### **MWWTP – RESPONSE TO GWRC REQUEST FOR FURTHER INFORMATION**

This letter has been prepared to address Greater Wellington Regional Councils (GWRC) request for further information for the Martinborough wastewater treatment plant discharge consent application (GWRC ref: WAR120258 [31707, 32044, 32045]) received 14 May 2014.

Figure 1: Groundwater and river stage height October 2002 – February 2004.

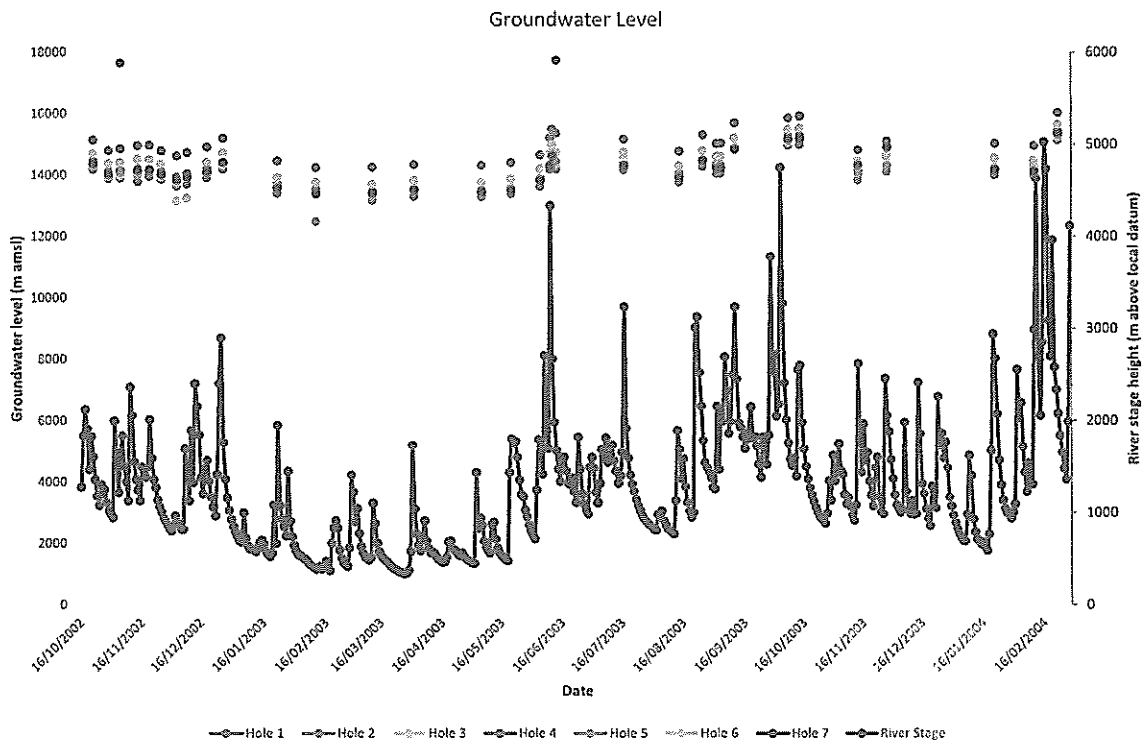
##### **1. Groundwater**

Ground contours from lidar data supplied by GWRC (1 m contours) have been used to estimate the elevation of the standpipes. Annex A shows the mapped ground elevation over the site. Figure 1 below shows the monitored groundwater levels corrected to metres above mean sea level (m amsl) compared to the recorded stage heights for the Ruamahanga@ Waihenga site.

A visual inspection of the plot suggests that groundwater levels follow the River rising and falling.

**Figure 3: Volume in Storage Pond**

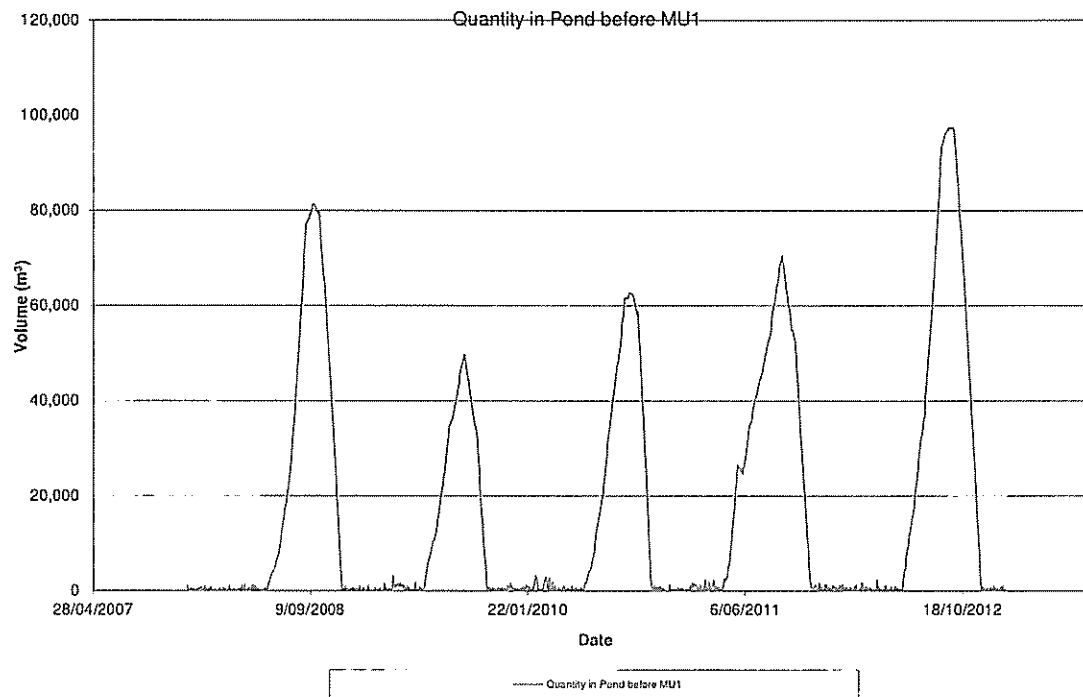
### 6. Determination of Storage Volume

Storage volume has been determined based on a daily water balance. The water balance used has been used by LEI for some time and was independently reviewed by Dave Horne (Massey University) in 2010. For reassurance storage volumes have also been calculated by AWT (Appendix 2, consent application) and have been run through the Massey Storage Pond Calculator. The storage volume as modelled is shown in Figure 3.

The pond volume is indicative and subject to development of long term data sets.
